Product Change Notification: PCN-24-201442**PCN Date:** 04-MAR-24**Customer:** Premier Farnell UK Ltd (PFUK) (101113)**Location:** Leeds**Agreement:** Agreement Unknown

T9A, T9E series relay.

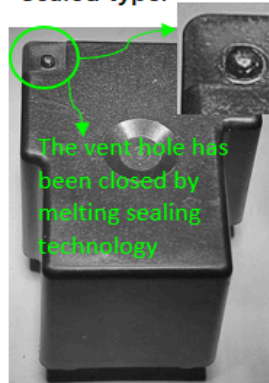
Dear customers, please be aware of an upcoming feature change to the listed T9A/T9E part numbers with the new melted sealing technology, there is no impact on the product performance with the change. You can see comparison details in the below PCN images table. Before: 1. For the sealed type, the nib is at the top corner of the case normally closed, and use UV glue to seal the vent hole on the base finally. 2. For the vented type, the nib is at the top corner of the case normally closed and the vent hole is at the bottom of the base normally opened. After: 1. For the sealed type, use melting sealing technology to seal the vent hole on the case finally, not use UV glue further and cancel the vent hole on the base. 2. For the vented type, it's a opened nib vent hole and cancel the vent hole on the base.

1. For the sealed type, use melting sealing technology to seal the vent hole on the case finally, not use UV glue further and cancel the vent hole on the base. 2. For the vented type, it's a opened nib vent hole and cancel the vent hole on the base.

New melted sealing technology implementation to cancel UV glue usage.
